**STIPULATION OF DISMISSAL OF
ACTION WITH PREJUDICE AND
PROPOSED ORDER**

FACILITY CHANGES ALREADY BEGUN AND PLANNED TO BE COMPLETED BY JANUARY 2011

- I. **Larkspur Ferry Terminal Parking Area (from Peter Margen's 7/16/10 report)**
 - **1** Remove anchor bolts on accessible side of picnic table, and bevel support plate to less than 1/2" in height
 - **6** Install 36" deep detectable warning strip along complete flush transition

Attachment 1

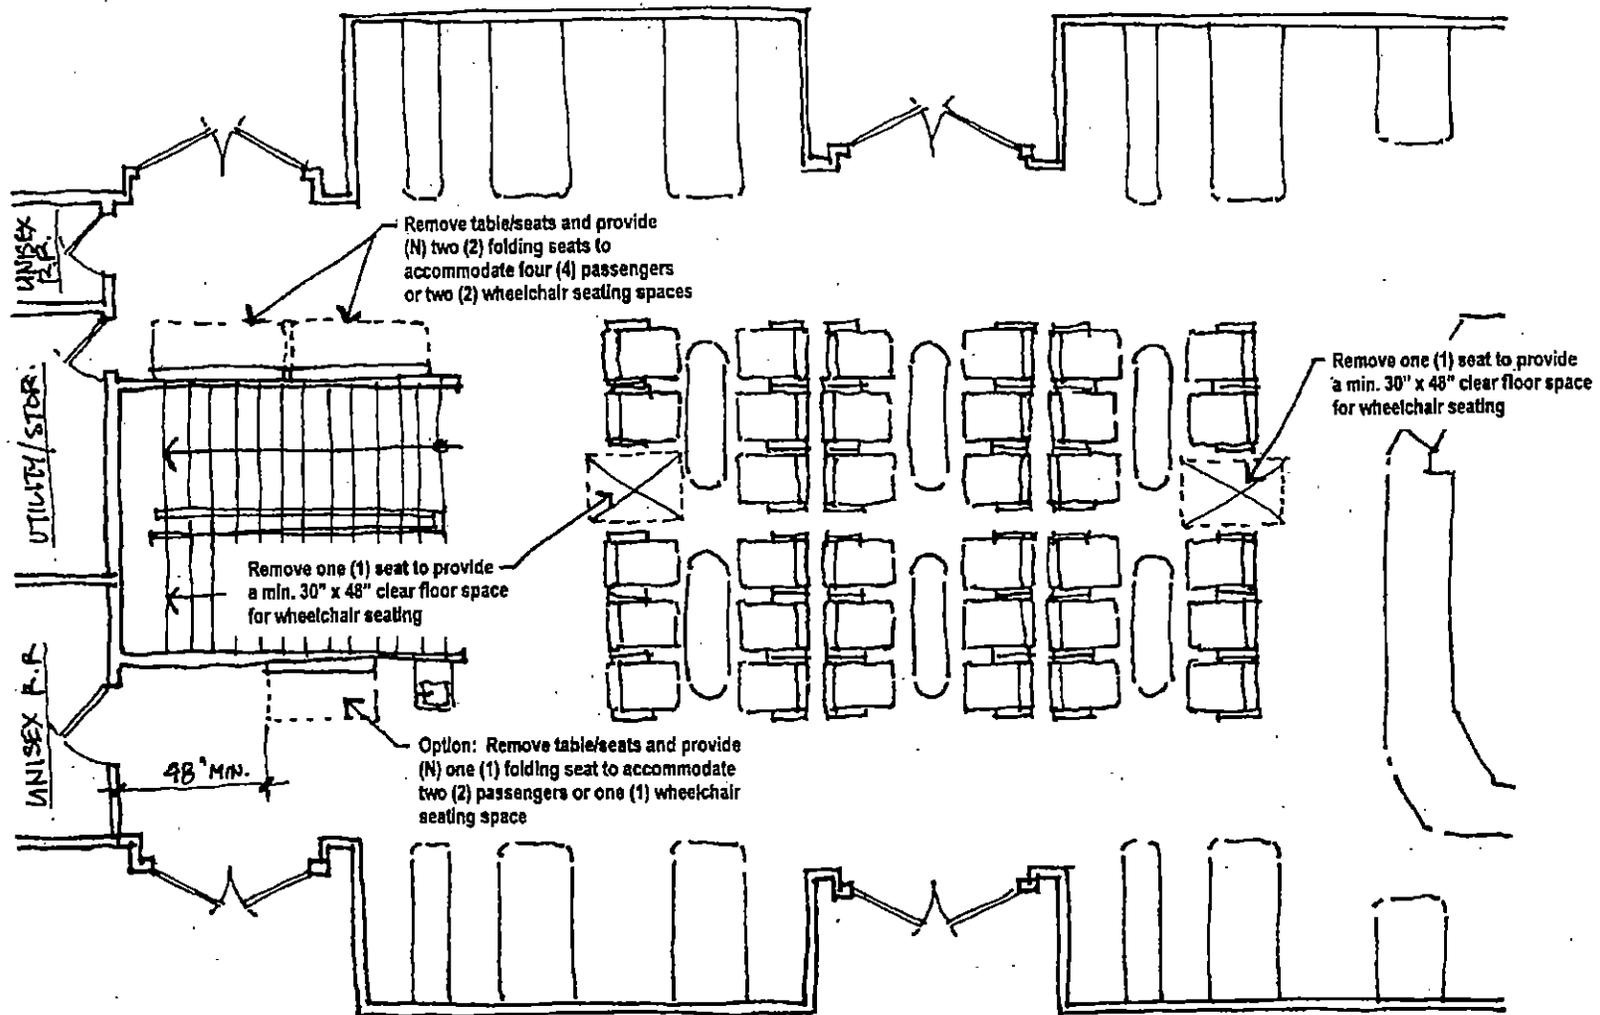
- **9.2** Replace Del Norte exterior door thresholds per current draft PVAG
- **9.4** Remove and replace seating per Attachment 1
- **9.5, .8-9** Improve accessibility to upper deck bathrooms consistent with options in Attachment 2

Attachment 3

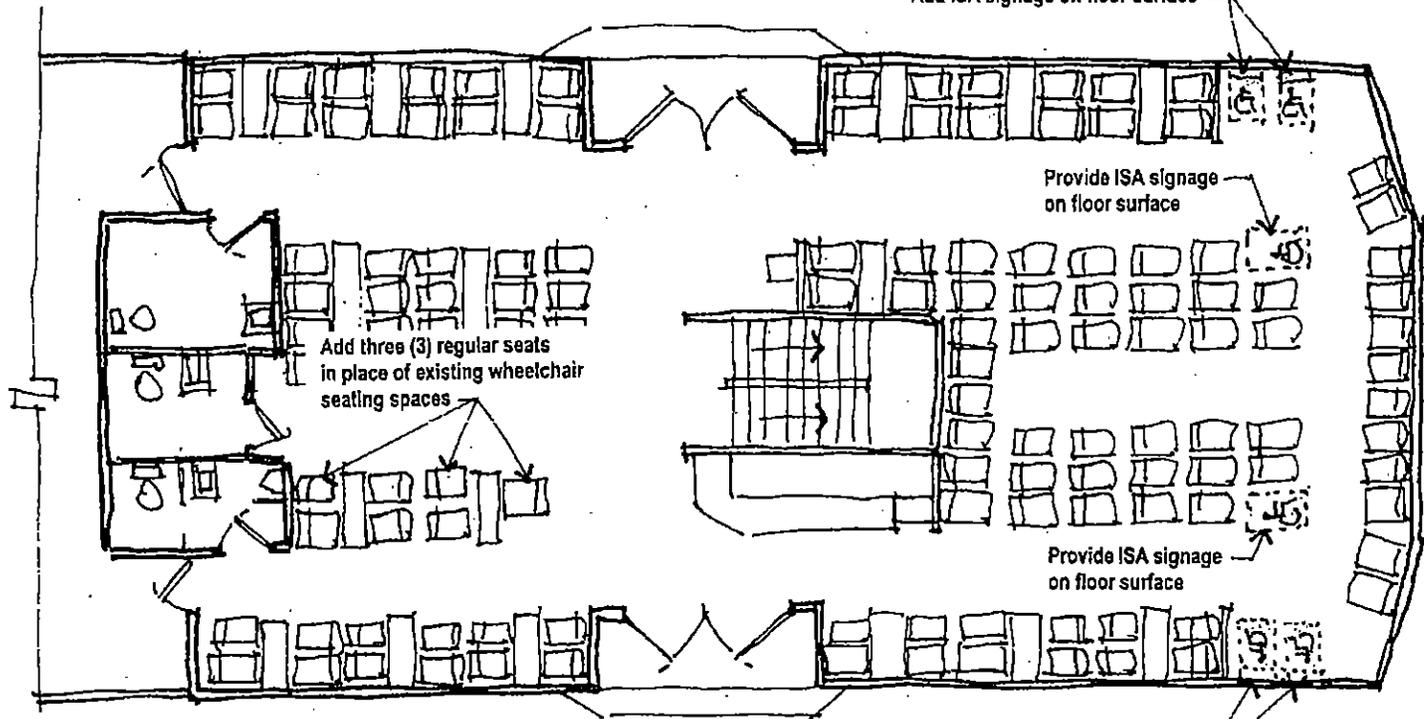
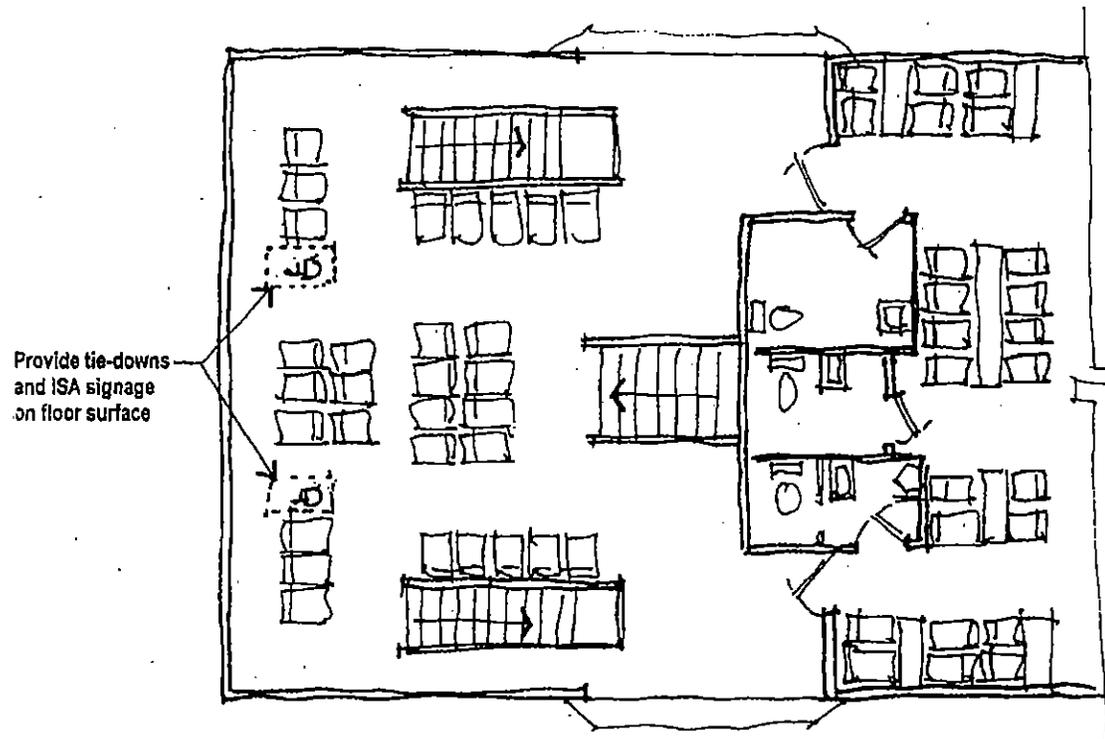
Remove four (4) seat bay.
Add new two (2) fold down seats
to accommodate two (2) passengers
or two (2) 30" x 48" clear floor space
for wheelchair seating.
Add ISA signage on floor surface

Add three (3) regular seats
in place of existing wheelchair
seating spaces

Provide ISA signage
on floor surface

Provide ISA signage
on floor surface

Remove four (4) seat bay.
Add new two (2) fold down seats
to accommodate two (2) passengers
or two (2) 30" x 48" clear floor space
for wheelchair seating.
Add ISA signage on floor surface

- **10.7** Remove and replace seating per Attachment 3
- **10.8, .11-19** Improve accessibility to upper deck bathrooms consistent with Attachment 4

Existing Accessible Parking Plan
 Larkspur Ferry Terminal - Larkspur, CA

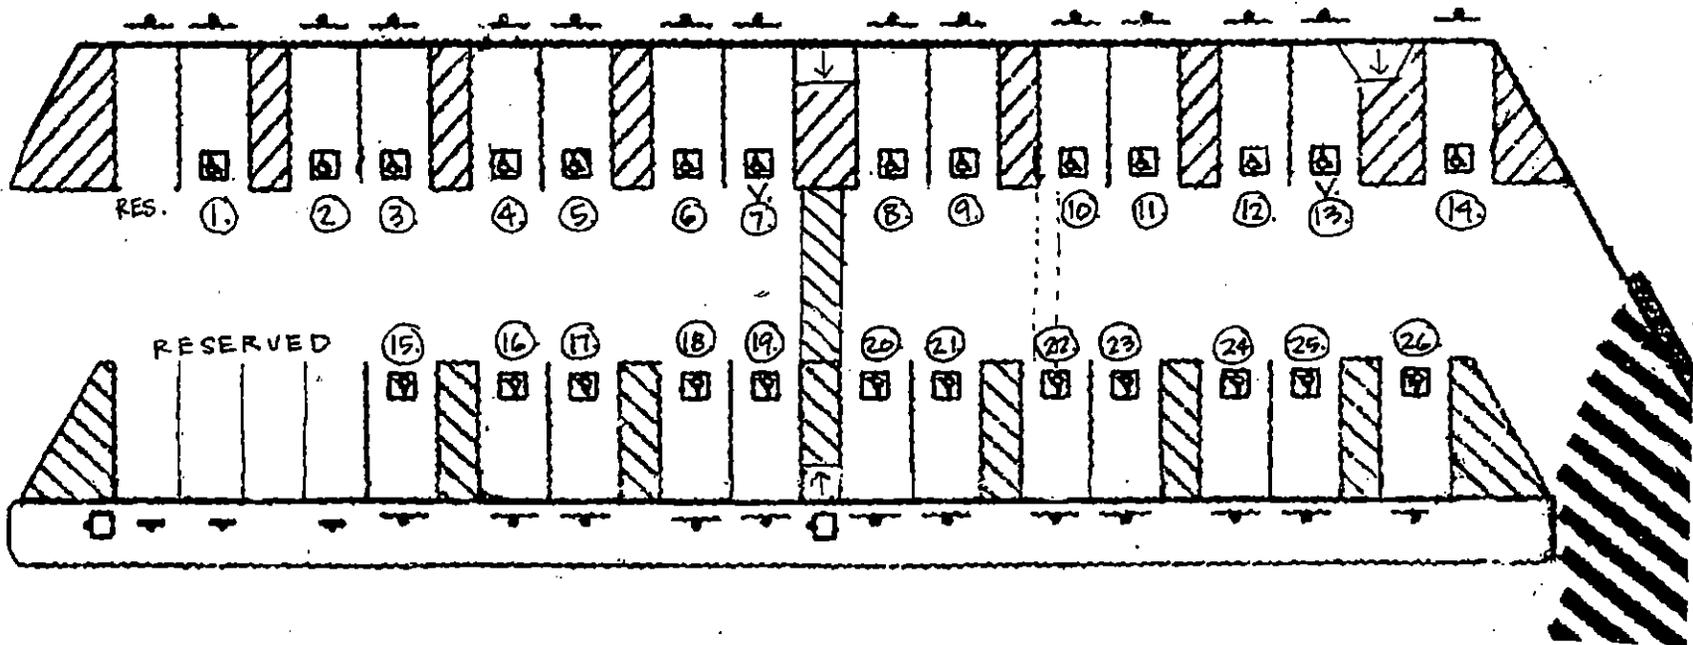
1.0 Parking									
Item	Element	Barrier	2001-CBC	CBC Requirements	ADAAG	ADAAG Requirements	Photo	Recommendation	
1.7	Parking #1-Slope	Parking Space #1 has a 3.5% running slope.	1129B.4(4)	Surface slopes of accessible parking spaces shall be the minimum possible and shall not exceed (1:50) 2% in any direction.	4.6.3	Parking spaces and access aisles shall be level with surface slopes not exceeding 1:50 (2%) in all directions.	57	Regrade parking space to provide max. 2% slope in all directions.

1.8	Parking #1-Access Aisle slope	Parking Space #1 access aisle has a 3.2% running slope.	1129B.4(4)	Surface slopes of accessible parking spaces shall be the minimum possible and shall not exceed (1:50) 2% in any direction.	4.6.3	Parking spaces and access aisles shall be level with surface slopes not exceeding 1:50 (2%) in all directions.	57	Regrade access aisle to provide max. 2% slope in all directions.

1.9	Parking #2-Slope	Parking Space #2 has a 4.0% running slope.	1129B.4(4)	Surface slopes of accessible parking spaces shall be the minimum possible and shall not exceed (1:50) 2% in any direction.	4.6.3	Parking spaces and access aisles shall be level with surface slopes not exceeding 1:50 (2%) in all directions.	56	Regrade parking space to provide max. 2% slope in all directions.

1.10	Parking #3-Slope	Parking Space #3 has a 3.8% running slope.	1129B.4(4)	Surface slopes of accessible parking spaces shall be the minimum possible and shall not exceed (1:50) 2% in any direction.	4.6.3	Parking spaces and access aisles shall be level with surface slopes not exceeding 1:50 (2%) in all directions.	56	Regrade parking space to provide max. 2% slope in all directions.

1.11	Parking #3-Access Aisle slope	Parking Space #3 access aisle has a 4.1% running slope.	1129B.4(4)	Surface slopes of accessible parking spaces shall be the minimum possible and shall not exceed (1:50) 2% in any direction.	4.6.3	Parking spaces and access aisles shall be level with surface slopes not exceeding 1:50 (2%) in all directions.	56	Regrade access aisle to provide max. 2% slope in all directions.

1.12	Parking #4-Slope	Parking Space #4 has a 4.2% running slope.	1129B.4(4)	Surface slopes of accessible parking spaces shall be the minimum possible and shall not exceed (1:50) 2% in any direction.	4.6.3	Parking spaces and access aisles shall be level with surface slopes not exceeding 1:50 (2%) in all directions.	55	Regrade parking space to provide max. 2% slope in all directions.

Existing Restroom Plan
Del Norte Ferry

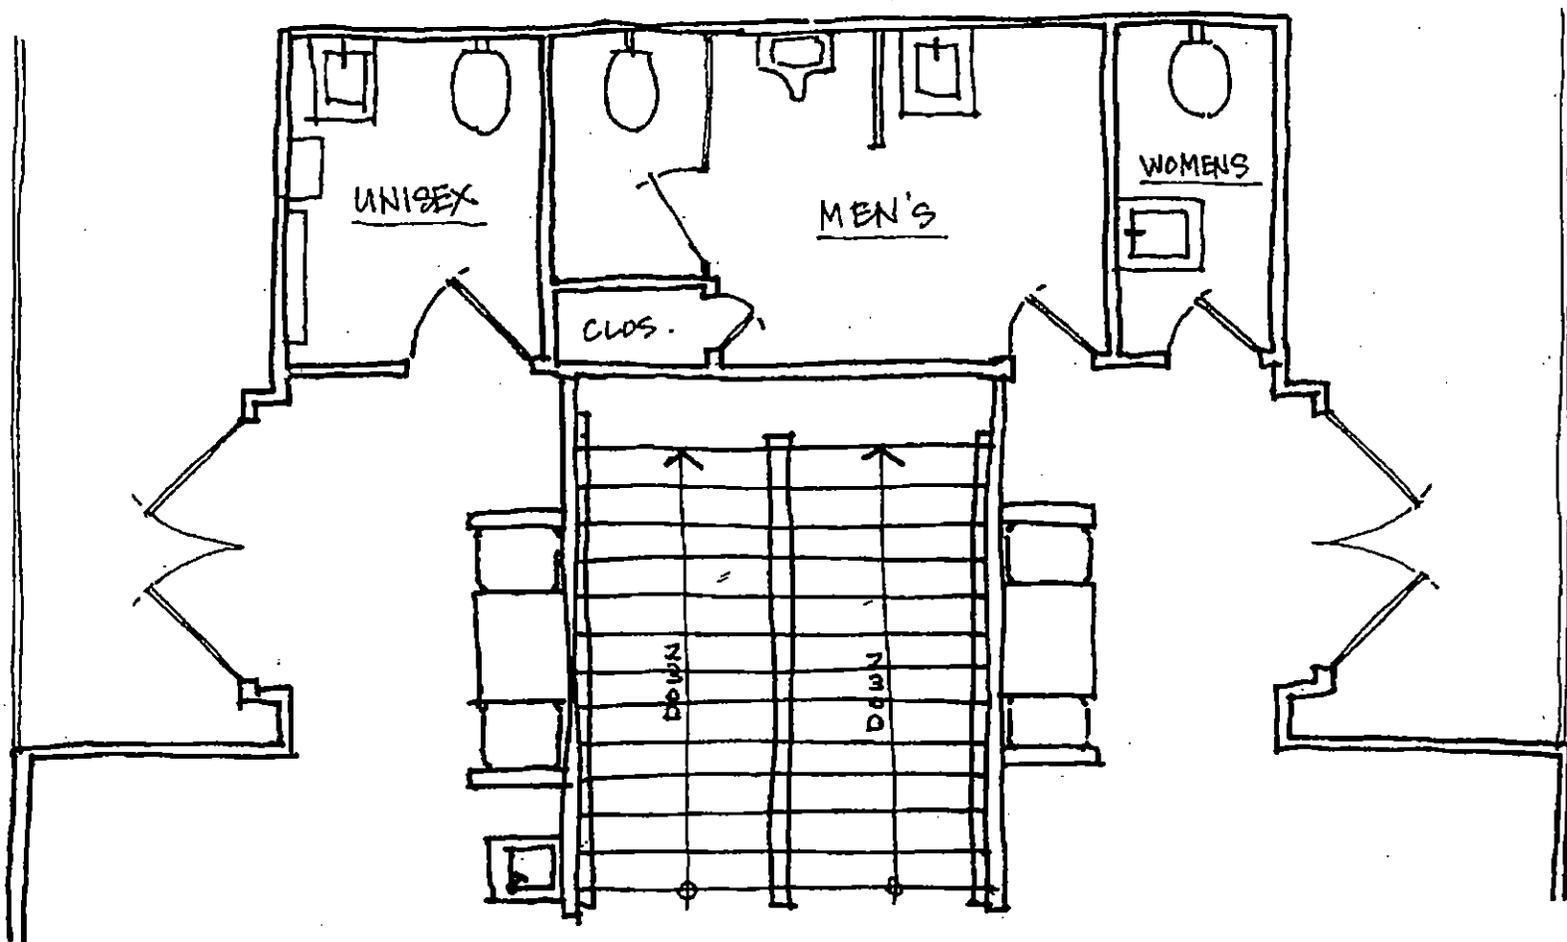
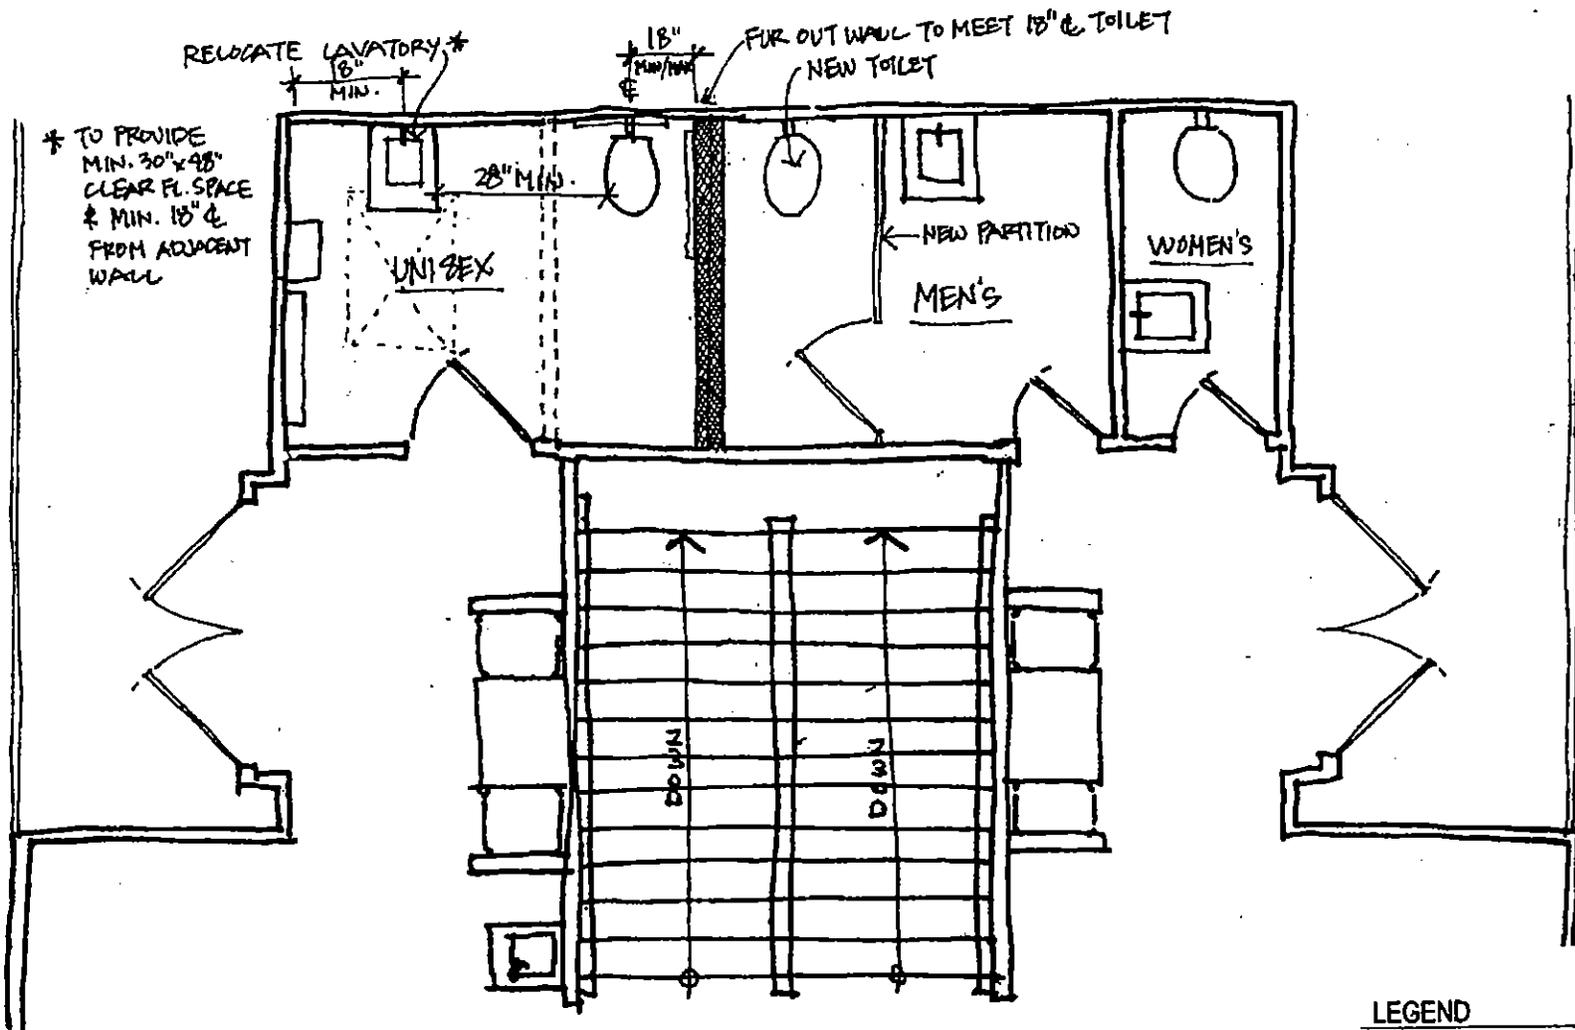
9.0 M.V. Del Norte Ferry								
Item	Element	Barrier	2001-CBC	CBC Requirements	ADAAG	ADAAG Requirements	Photo	Recommendation
9.11	Toilet-Centerline	The toilet is mounted 16½" to the CL from the adjacent wall.	1115B.7.1 3	18" minimum/maximum	Fig. 28	18" minimum/maximum	213	Renovate the restroom to provide all accessible features. See Proposed Conceptual Restroom Plan

9.13	Grab Bars-Height	The grab bar at the side of the toilet is 36" AFF.	1115B.8.1	Securely attached 33" AFF and parallel to the floor, except that where a tank-type toilet is used which obstructs placement at 33"; the grab bar may be as high as 36".	Fig. 29 & 30	Between 33"-36" AFF.	213	Renovate the restroom to provide all accessible features. See Proposed Conceptual Restroom Plan

Proposed Conceptual Accessible Restroom Plan (not for construction)

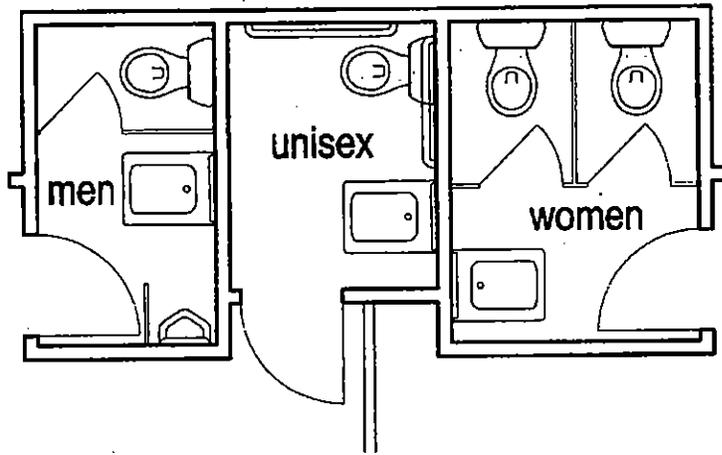
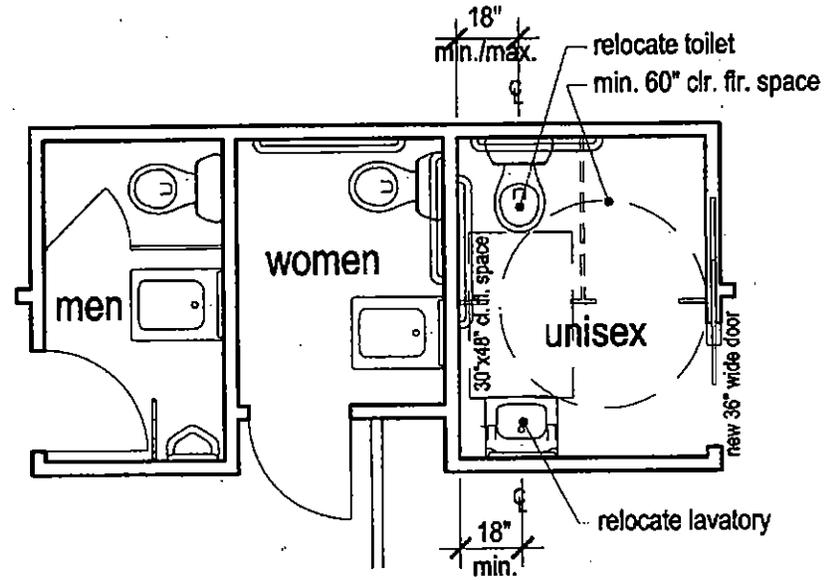
10.11	Entry Door-Recess	The entry door is recessed 18" and there is no strike side clearance provided on the pull side of the door.	1133B.2.5.3	Where the plane of the doorway is offset 8 or more inches (205 mm) from any obstruction within 18-inches (455 mm) measure laterally on latch side, the door shall be provided with maneuvering clearance for front approach. See Figure 11B.33(a)	Fig 25	On the side toward which an interior door swings, 18" of clear space is required beyond the strike-edge (latch side) of the door. 24" is preferred.	22	<p>Renovate the women's restroom to create an accessible unisex restroom. Designate the "accessible" restroom as the women's restroom.</p> <p>See Proposed Conceptual Restroom Plan</p>

10.0 M.V. Mendocino Ferry								
Item	Element	Barrier	2001-CBC	CBC Requirements	ADAAG	ADAAG Requirements	Photo	Recommendation
10.12	Lavatory – Knee Space	The clear space under the lavatory is 28" AFF at the face of the unit.	1115B.2.1.2 .1	All lavatories that are designated to be accessible shall have a vertical clearance measured from the bottom of the apron or the outside bottom edge of the lavatory of 29". Knee clearance below the lavatory shall extend a minimum of 30" in width by 17" in depth. See Figure 11B-10.	4.19.2	Provide a clearance of at least 29" AFF to the bottom of the apron.	24	Renovate the women's restroom to create an accessible unisex restroom. Designate the "accessible" restroom as the women's restroom. See Proposed Conceptual Restroom Plan

10.14	Toilet-Centerline	The toilet is mounted 17½" to the CL from the adjacent wall.	1115B.7.1 3	18" minimum/maximum	Fig. 28	18" minimum/maximum	25	Renovate the women's restroom to create an accessible unisex restroom. Designate the "accessible" restroom as the women's restroom. See Proposed Conceptual Restroom Plan

10.16	Toilet – Clear Floor Space	The clear floor space in the front of the toilet is 35".	1115B.7.2	A minimum 48" long clear space shall be provided in front of the toilet.	4.17.3 Fig. 30	Standard toilet stalls with a minimum depth of 56" shall have wall-mounted water closets. If the depth of a standard toilet stall is increased at least 3" (59") then a floor-mounted water closet may be used.	23	Renovate the women's restroom to create an accessible unisex restroom. Designate the "accessible" restroom as the women's restroom. See Proposed Conceptual Restroom Plan

10.0 M.V. Mendocino Ferry									
Item	Element	Barrier	2001-CBC	CBC Requirements	ADAAG	ADAAG Requirements	Photo	Recommendation	
10.18	Toilet – Paper Dispenser	The toilet paper dispenser is mounted >36" from the rear wall.	1115B.9.3	Toilet tissue dispensers shall be located on the wall within 12" of the front edge of the toilet seat.	Fig. 30	Max. 36" from the outside edge of the toilet paper dispenser.	27	Renovate the women's restroom to create an accessible unisex restroom. Designate the "accessible" restroom as the women's restroom. See Proposed Conceptual Restroom Plan

10.19	Grab Bar-Extension	The grab bar at the side of the toilet extends 53" from the rear wall.	1115B.8.1	The front end positioned 24" in front of the toilet stool.	Fig. 29	Side grab bar shall be a min. 54" from the rear wall.	23	Renovate the women's restroom to create an accessible unisex restroom. Designate the "accessible" restroom as the women's restroom. See Proposed Conceptual Restroom Plan
